# PERMIT

SEWAGE DISPOSAL SYSTEM

MARYLAND STATE DEPARTMENT OF HEALTH

SUBDIVISION \_\_\_\_\_ ROAD \_\_\_\_\_ LOT \_\_\_\_\_  
Holiday Hills Vista Rd. 26  
PROPERTY OWNER \_\_\_\_\_  
ADDRESS Holiday Hills Baptist Church

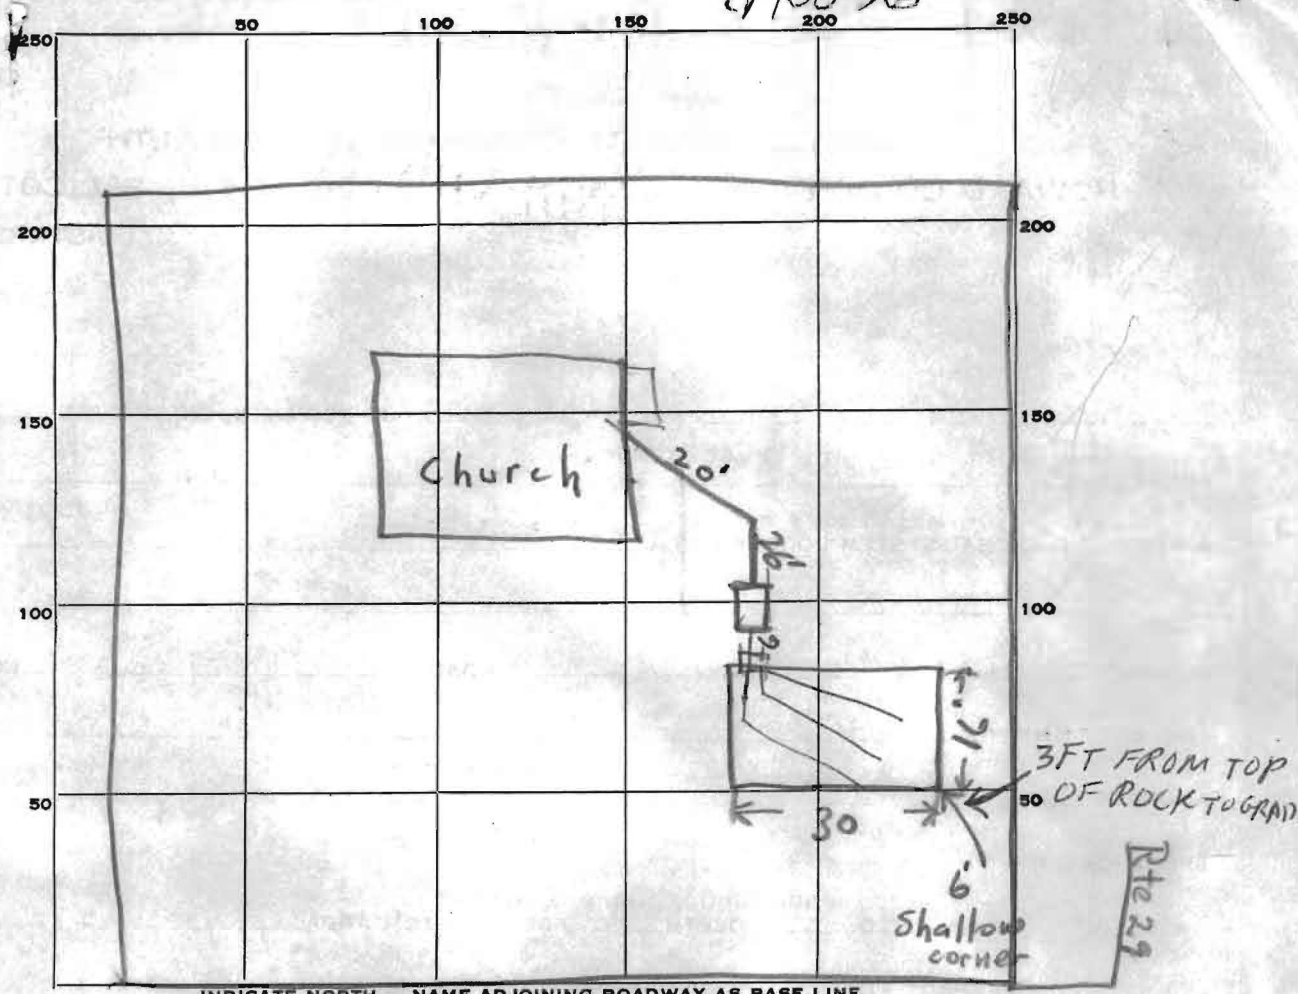
~~Two dry wells each 12 ft. in dia. by 8 ft. deep below the inlet located 10 ft. off the front property line and 82 ft. off the right side property line and 55 ft. off the front property line and 60 ft. off the right side property line respectively. Maintain a distance of 35 ft. between dry wells measured edge to edge. Locations determined when facing the lot from Vista Road. Inlet no deeper than 4 ft.~~  
LEACHING BED - 400 sq. ft. in exact location as was given for dry well.

LEACHING BED - call for inspection of leaching bed excavation before any gravel is installed.  
PLANS APPROVED BY \_\_\_\_\_ DATE \_\_\_\_\_

SEPTIC TANK, LEVEL OK Top is 4ft sft below grad CLEANOUTS OK

REMARKS 8/2/65 - Partial OK, - OK to cover work to septic tank - JH

DATE SYSTEM APPROVED 3 AUG 65 INSPECTOR Raymond Hodges
